**TO:** Jeanne Shaffer, Groundwork Entitlement Services, LLC  
**FROM:** BrieAnna Simon, Associate Planner  
**DATE:** March 13, 2020  
**SUBJECT:** SP19-062, Site Plan, Horseshoe Ridge Block 1 Lot 2 - Multi-Tenant Commercial Review Comments v3

# PARKER MIXED-USE RETAIL

LOT 2, BLOCK 1, HORSESHOE RIDGE SUBDIVISION 1ST AMENDMENT  
 A PARCEL OF LAND LOCATED IN THE SE 1/4 OF SECTION 28, TOWNSHIP 6 SOUTH, RANGE 66 WEST OF  
 THE 6TH PRINCIPAL MERIDIAN  
**SITE PLAN REVIEW**

SHEET INFORMATION  
**LS 1.1**

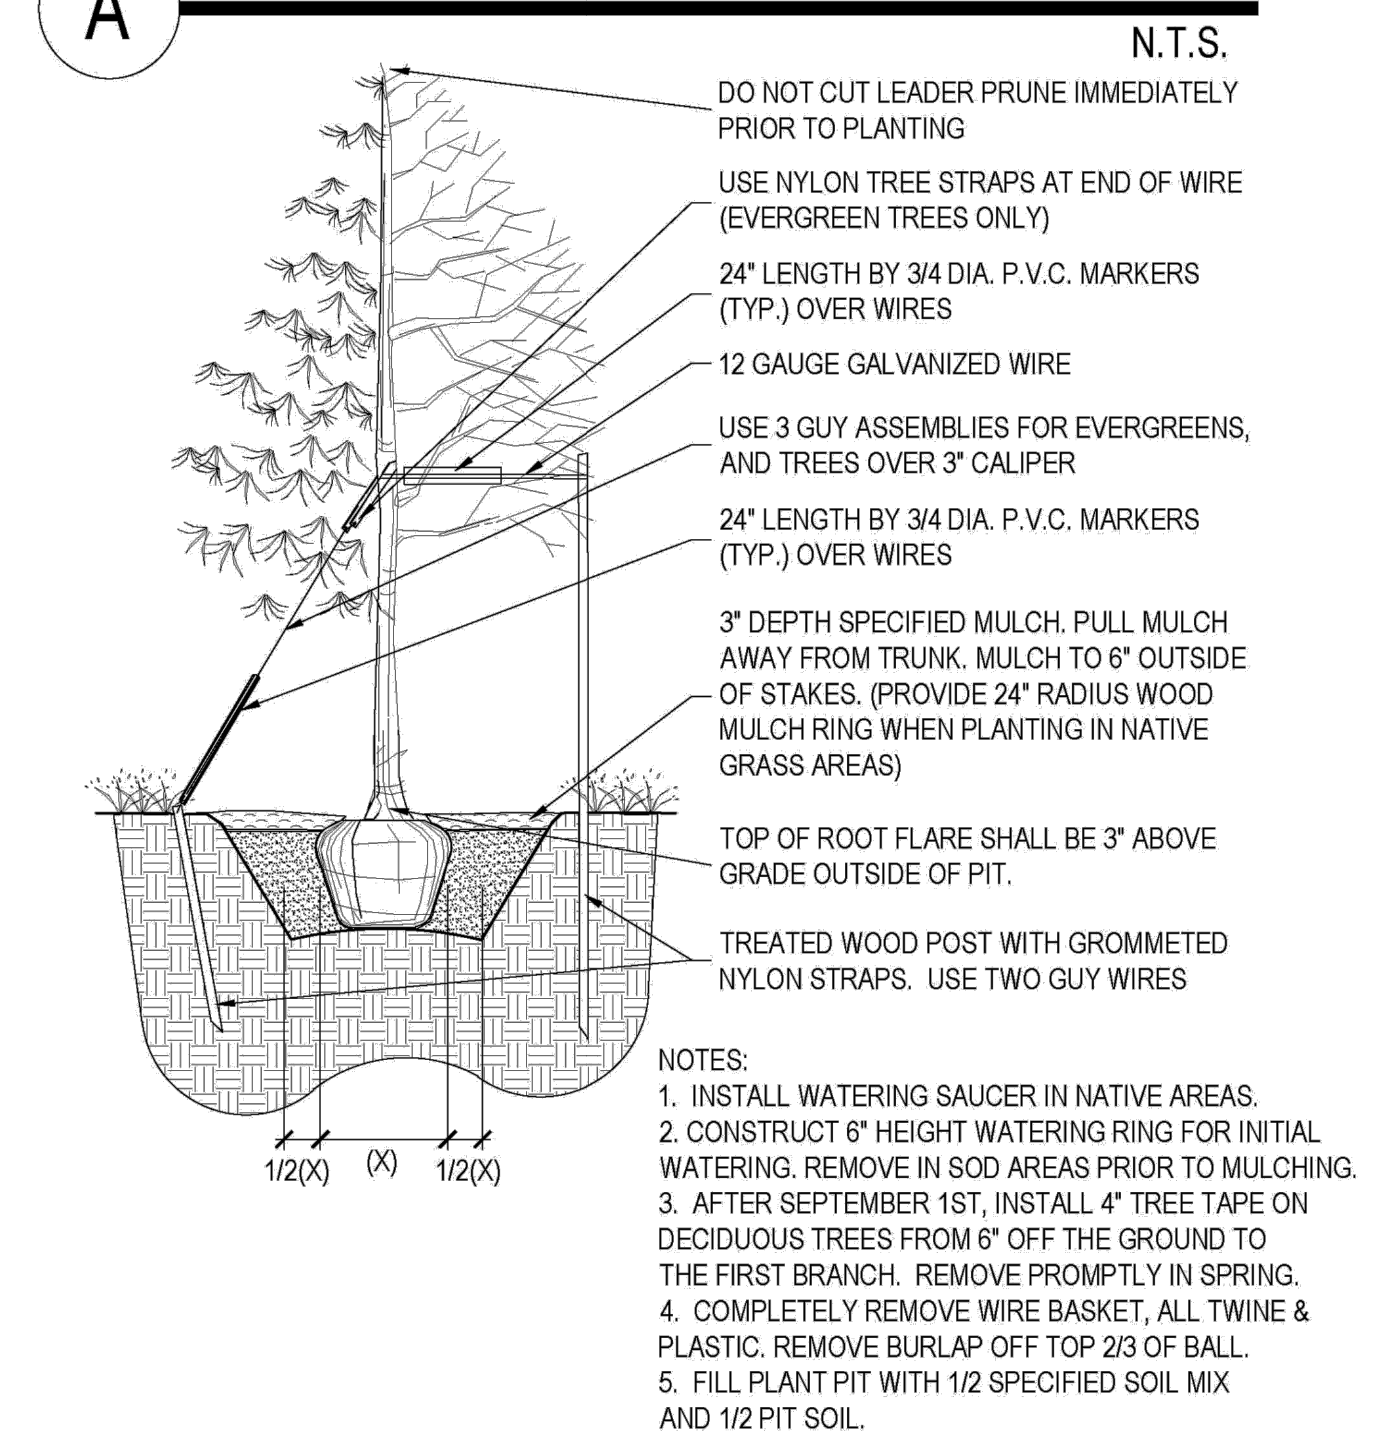
This note is confusing. Only show the number of shrubs being provided and do not count perennials towards the number of shrubs provided.

This line item in the table is confusing. It might be more clear if for the trees and shrubs provided only show what is being provided. Add a column from ornamental grasses if those are being provided in lieu of shrubs. Then add a foot note to explain what is being substituted for what in each column.

One (1) ornamental grass in a five-gallon container or three (3) ornamental grasses in one-gallon containers may be substituted for one (1) shrub per Section 13.06.070. Please update accordingly.
